SI B11 15 17
Engine

B46/48 ENGINE: OIL LEAK FROM TURBOCHARGER RETURN LINE

This Service Information bulletin replaces SI B11 15 17 dated **October 2017**

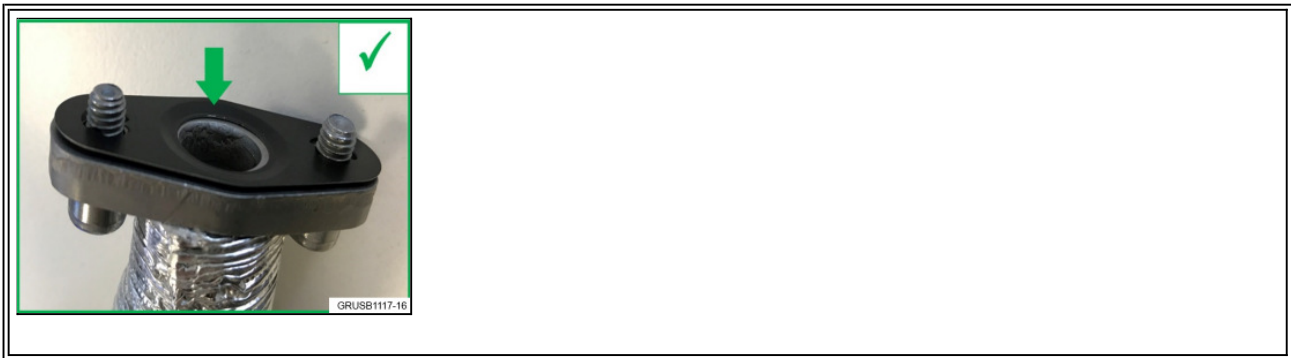
Incorrect assembly of the "asbestos-free gasket". The gasket was incorrectly flipped during installation with the bead raised toward the turbocharger, as shown.

Replace the turbocharger oil return line, asbestos-free gasket and the O-ring 16 x 2 mm according to REP 11 42 210 - "Removing and installing/sealing or replacing the oil return line for the exhaust turbocharger".

Note: Mount the "asbestos-free gasket" so that its bead is raised towards the oil return line as shown.
